SC0348, Brake Timing

(June 2011)

MACK Trucks has determined that a non-compliance may exist with Federal Motor Vehicle Safety Standard 121, "Air Brake Systems", on 2008-2011 GU model vehicles manufactured with front towing glad hands. The non- compliance is that the service brake timing, both actuation and release, exceeds the limits as prescribed by the federal standard.

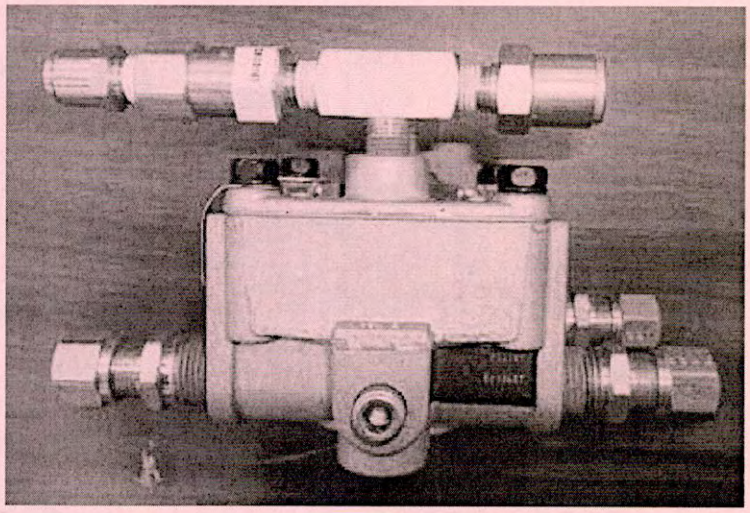
2. Remove the air line and fitting going to the delivery port of the valve shown as illustrated. (Valve is located on the left frame rail just behind the cab.)

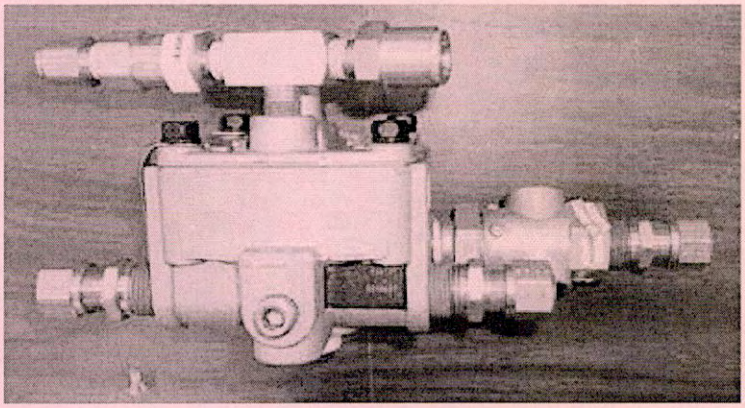
3. Install the QR-L valve into the now vacant port.

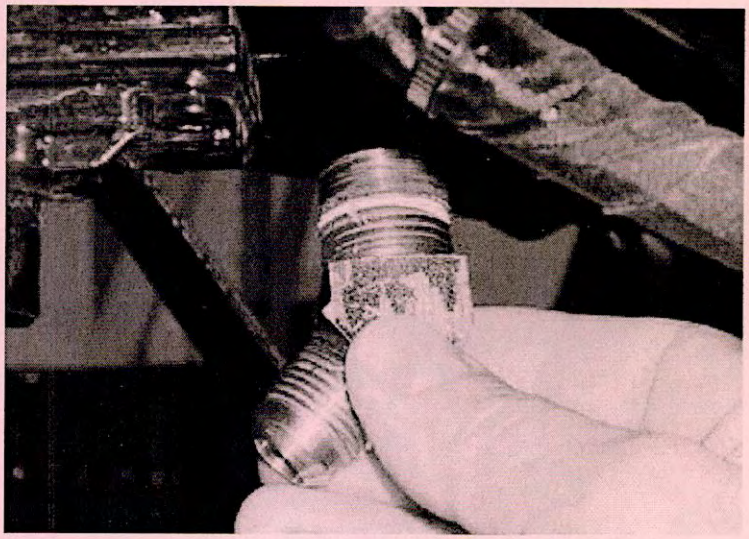
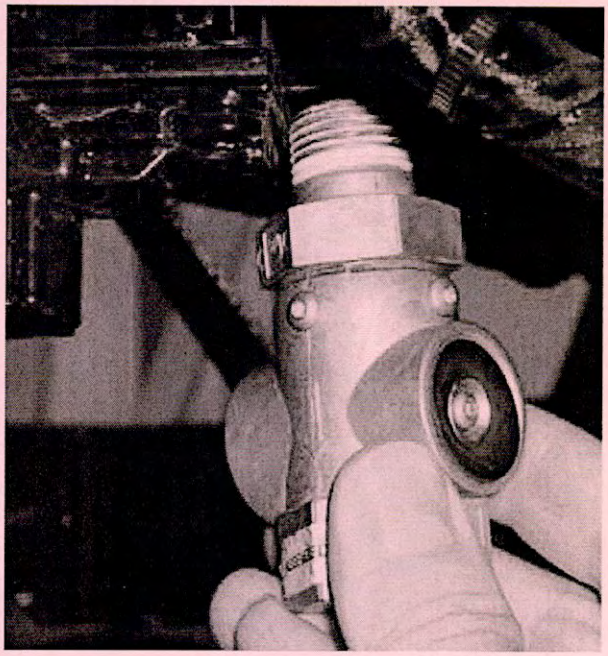
2. Locate the valve assembly (Relay + ABS) on the front bogie cross member and perform the following steps as indicated in the illustration.

A. Disconnect the brake hose coming from the front rear axle and going to the tee after the ABS modulator.

B. Remove the bottom fitting in the tee and install a QR-L into the tee.

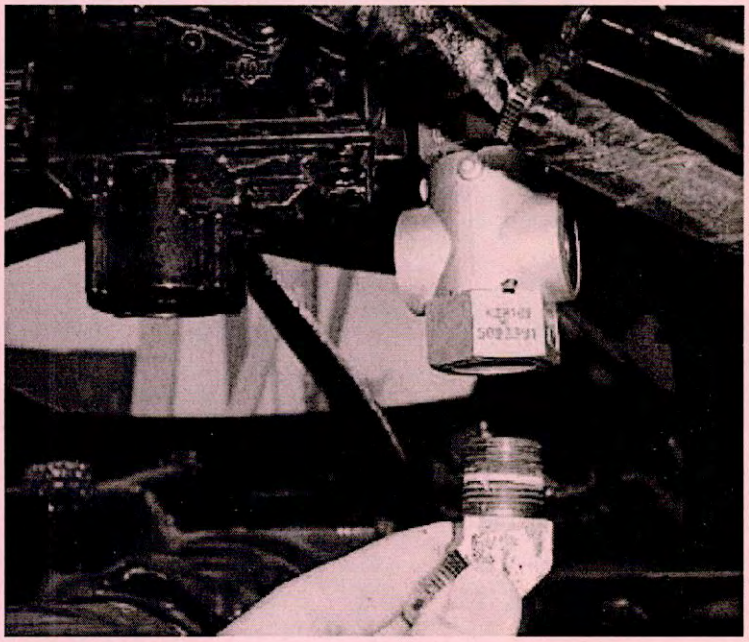
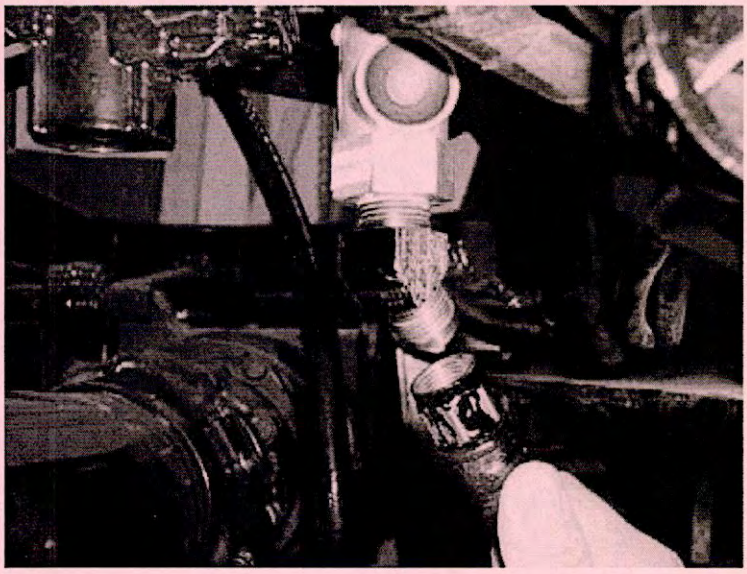
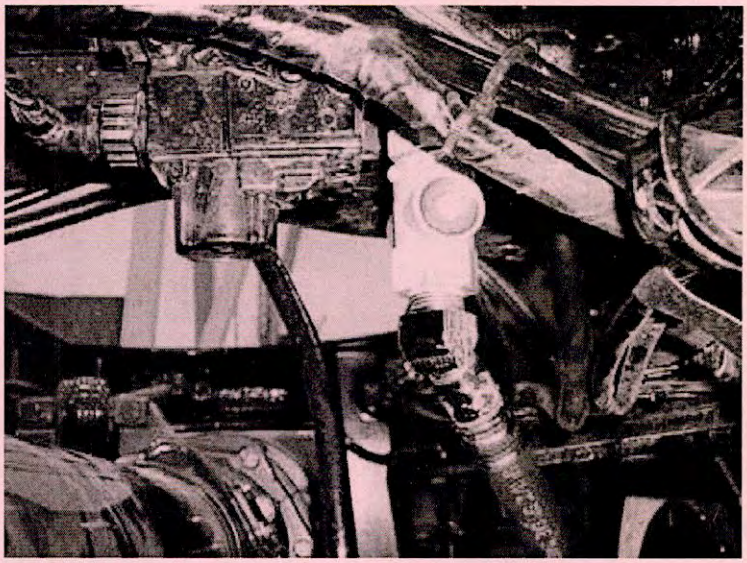
C. Install the fitting onto the QR-L and reinstall the brake hose.
